Wisconsin Department of Transportation

Proposal #18: 4090-06-71, WISC 2021 036
Village of Campbellsport
Baumann Street – Triple S Road
STH 67
Fond Du Lac County

Letting of December 8, 2020

This is Addendum No. 01, which provides for the following:

Addendum No. 01
 ID 4090-06-71
 Revised Sheet 29
 November 19, 2020

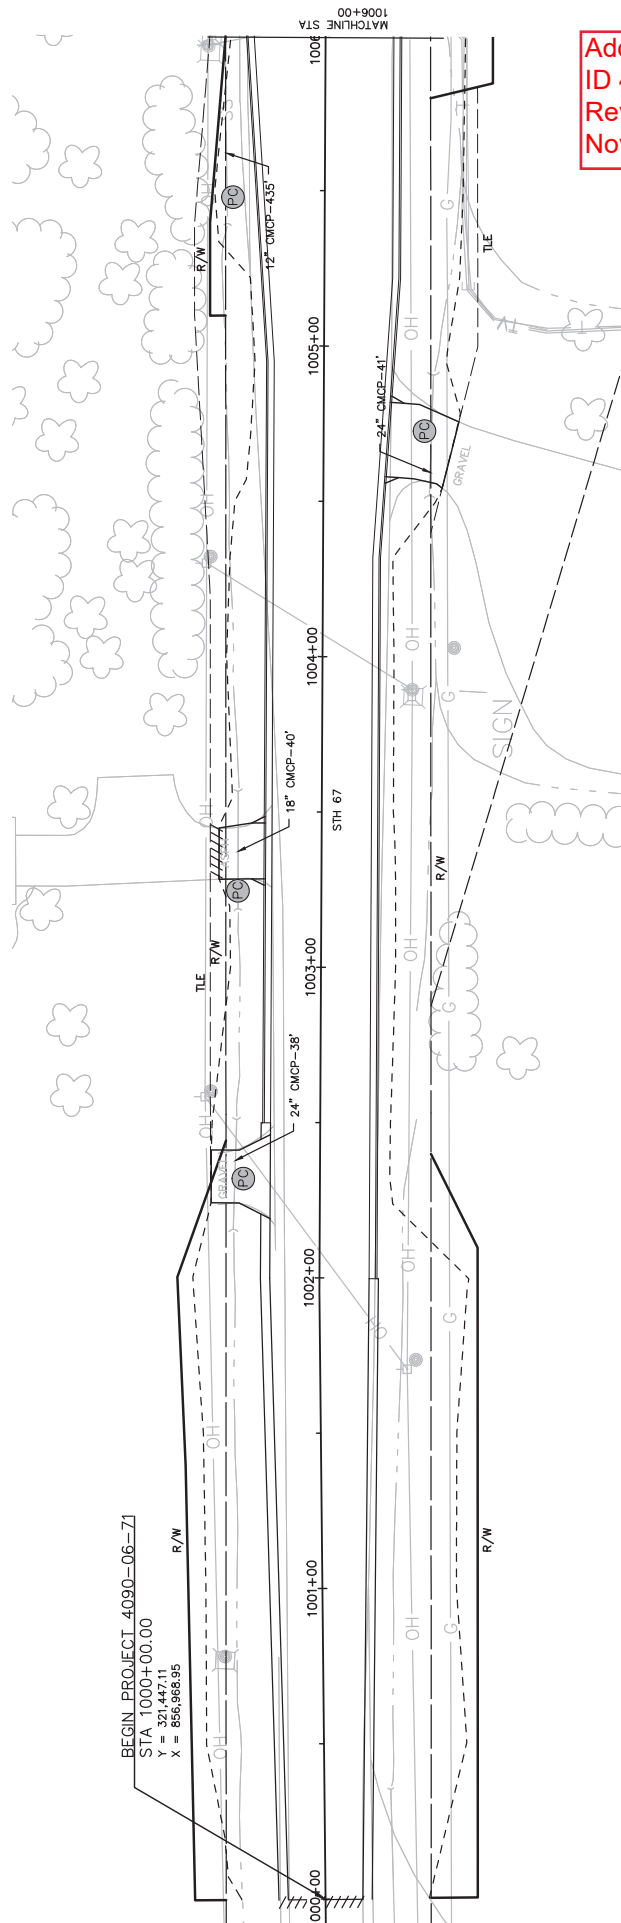
Revised Plan Sheets	
Plan Sheet	Plan Sheet Title (brief description of changes to sheet)
29-48	Removals_New Bid items added to Legend
32	Removals_Callouts for Temporary Salvaged United States Postal Service Cluster Box and Permanent Salvaged United States Postal Service Cluster Box added at station 1018+64.
34	Removals_Callouts for Temporary Salvaged United States Postal Service Cluster Box and Permanent Salvaged United States Postal Service Cluster Box added at station 1032+64.
35	Removals_Callouts for Temporary Salvaged United States Postal Service Cluster Box and Permanent Salvaged United States Postal Service Cluster Box added at station 1040+35.
37	Removals_Callouts for Temporary Salvaged United States Postal Service Cluster Box and Permanent Salvaged United States Postal Service Cluster Box added at station 1049+15.
38	Removals_Callouts for Temporary Salvaged United States Postal Service Cluster Box and Permanent Salvaged United States Postal Service Cluster Box added at station 1054+94.

Addendum No. 01
 ID 4090-06-71
 Revised Sheet 30
 November 19, 2020

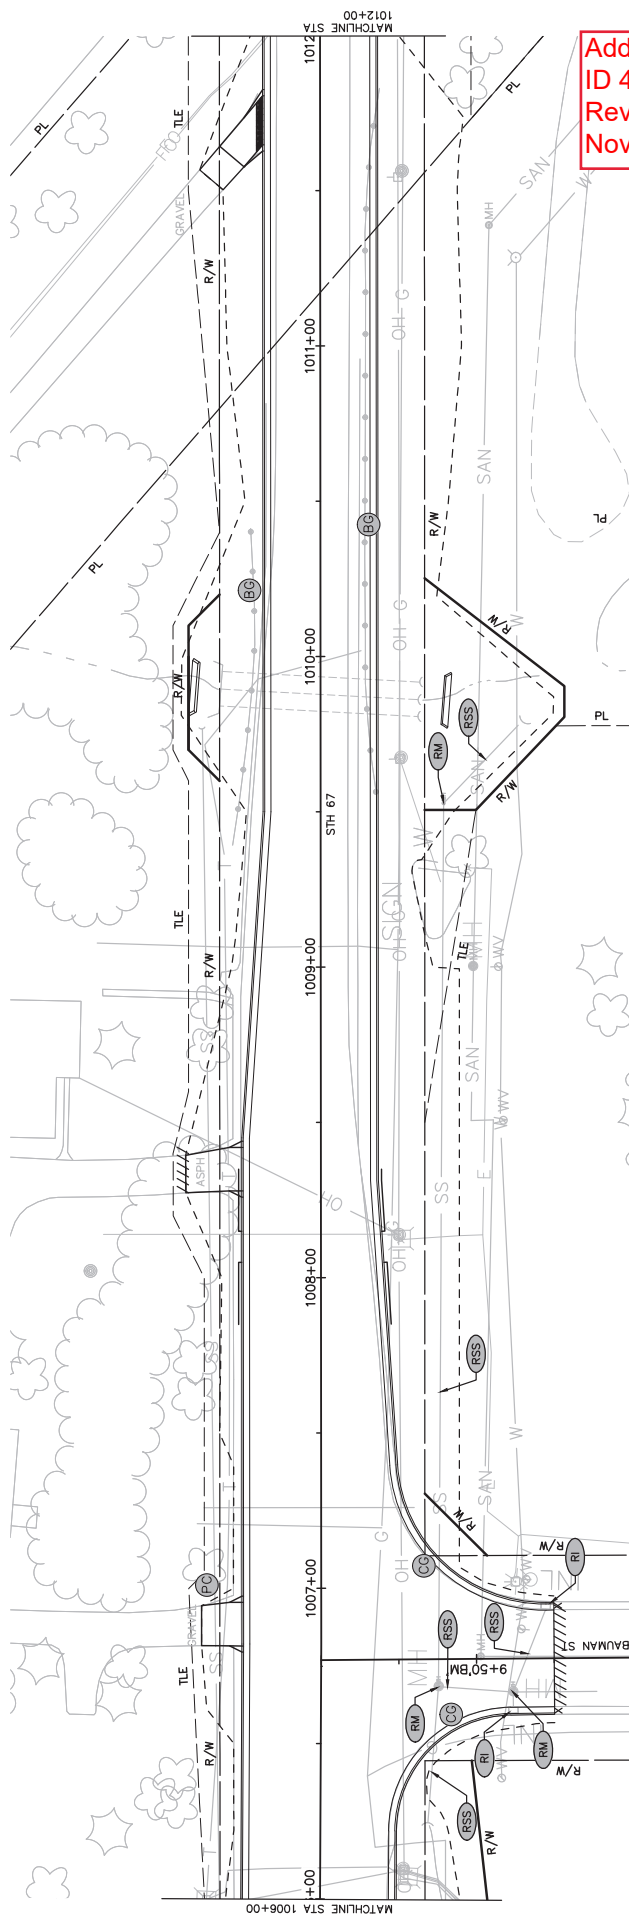
REMOVE STORM SEWER PIPE STA. 1006+68 - STA. 1009+52, RT TO THE GREATEST EXTENT POSSIBLE WITHOUT IMPACTING THE "WELCOME TO CAMPBELLSPORT" SIGN.

Addendum No. 01
ID 4090-06-71
Revised Sheet 39
November 19, 2020

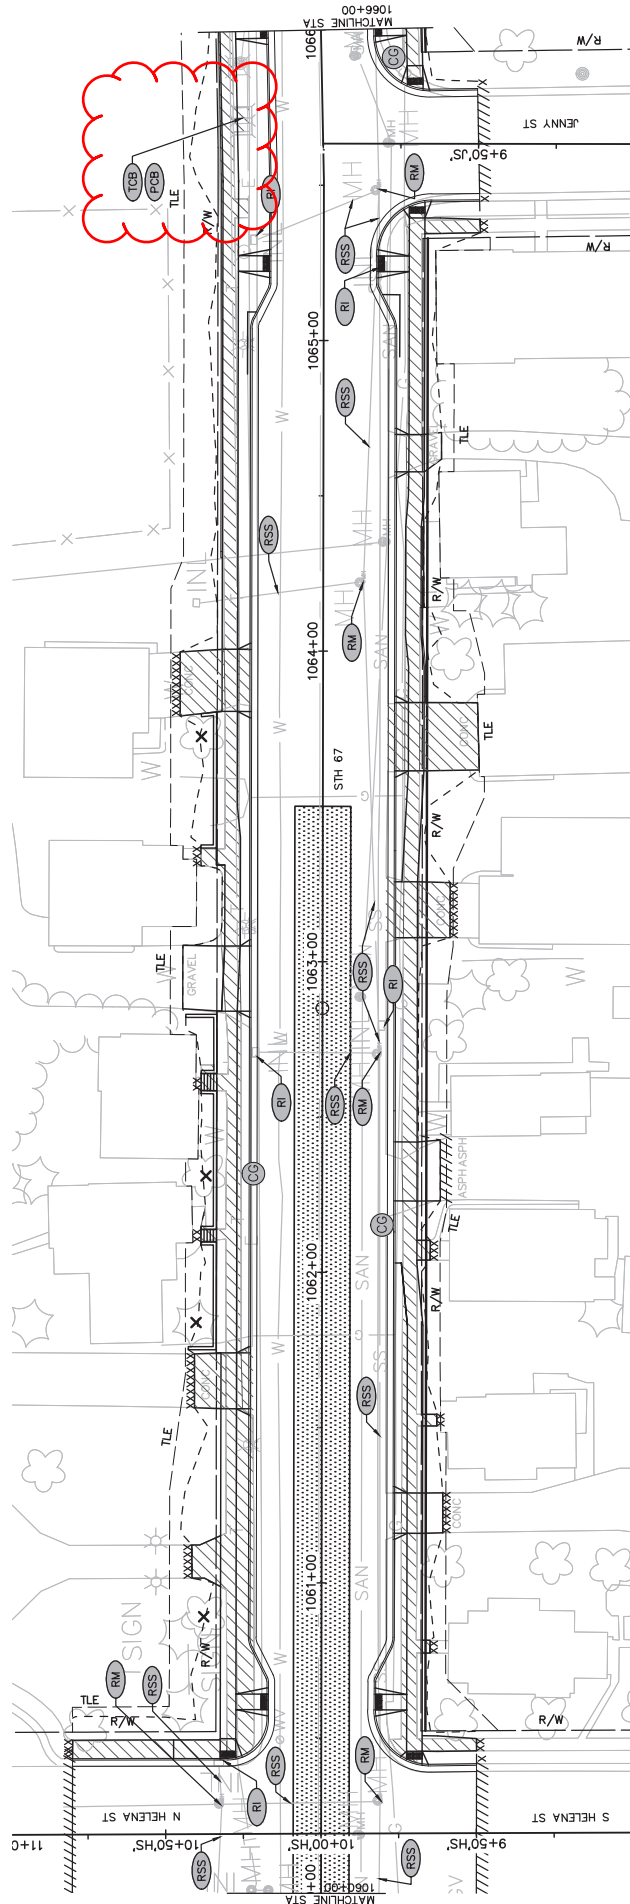
39	Removals_Callouts for Temporary Salvaged United States Postal Service Cluster Box and Permanent Salvaged United States Postal Service Cluster Box added at station 1065+72.
40	Removals_Callouts for Removing Concrete Raceway at Utility Crossing and Removing Concrete Raceway at Roadway Crossing added at station 1071+95.
102-118	Storm Sewer_Many storm sewer_pipes originally labeled as SSPRC in the profile view have be revised to SSPIII-A be reflect the bid item change.
183	Miscellaneous Quantities_Removing Concrete Raceway Table added to sheet. Tables arranged to correct order based on Bid item Number. Bid item number of "Removing Beam Guard Retaining Wall" revised to 204.9090.S.02.
193-196	Miscellaneous Quantities_Storm Sewer Pipe Tables revised to show bid item change. Storm Sewer Pipe Reinforced Concrete Class III updated to Storm Sewer Pipe Class III-A for pipe sizes 12-inch thru 36-inch.
221	Miscellaneous Quantities_United States Postal Service Cluster Box Table added to sheet. Tables arranged to correct order based on Bid Item Number. Tables for Seismograph and Crack and Damage Survey items were removed from this sheet and added to the 4090-06-72 MQ sheets.
